# Access Compliance Report

## Public Rights-of-Way

Intersection ID: 29294	Main Street: LOOKING_GLASS_LN	Cross Street: FAR_WEST_DR	Location: SW
ADA ID: 06C2FEB822FC	Ramp Type: PerpDiag	Initial Pass/Fail: Fail	Overall Compliance: No
Codes/Mitigation Info/Possible Solution		Field Measurements/Component Compliance	
Severity Score: 30

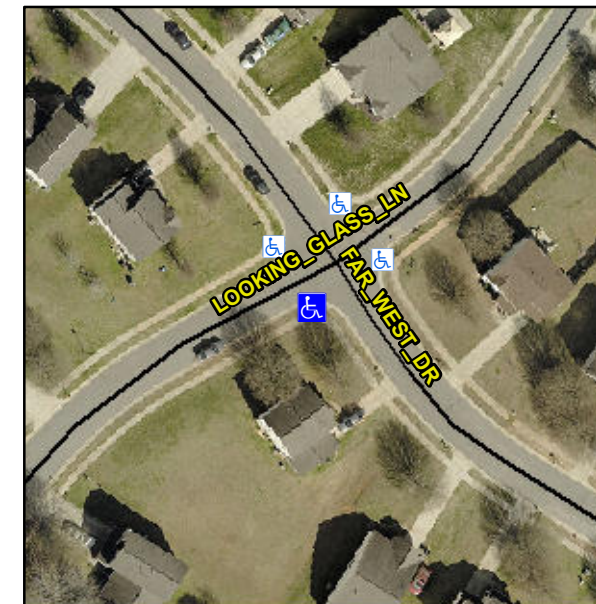
**Not Found, R304.5.1, R304.5.3**

Compliance	Description	Data	Compliance	Description	Data
N/A	Ramp Length (in)	54.5	Yes	Ramp Slope (%)	7.9
No	Ramp Width (in)	32.5	No	Ramp XSlope (%)	6.6
N/A	Flare Type LT	N/A	N/A	Flare Type RT	N/A
N/A	Flare Slope LT (%)	N/A	N/A	Flare Slope RT (%)	N/A
N/A	Flare Traversable LT?	N/A	N/A	Flare Traversable RT?	N/A
N/A	Landing Length (in)	N/A	N/A	DWS Provided?	N/A
N/A	Landing Width (in)	N/A	N/A	DWS Contrast?	N/A
N/A	Landing Slope (%)	N/A	N/A	DWS Length (in)	N/A
N/A	Landing X Slope (%)	N/A	N/A	DWS Full Width?	N/A
N/A	Landing Curb? (Y/N)	N/A	N/A	DWS Offset (in)	N/A
N/A	Shared Landing?	N/A			
N/A	Gutter Ponding?	N/A	N/A	Gutter Slope (%)	N/A
N/A	Gutter Lip Ht (in)	N/A	N/A	Gutter X Slope (%)	N/A
N/A	Painted X Walk1?	No	N/A	Painted X Walk2?	No
	X Walk 1 Direction	To E		X Walk 2 Direction	To W
N/A	X Walk 1 Width (in)	N/A	N/A	X Walk 2 Width (in)	N/A
	X Walk 1 Slope (%)	3.8		X Walk 2 Slope (%)	1.7
	X Walk 1 X Slope (%)	2.0		X Walk 2 X Slope (%)	4.1

**Remove & Replace Curb Ramp With Two New Directional Ramps or Equivalent.**
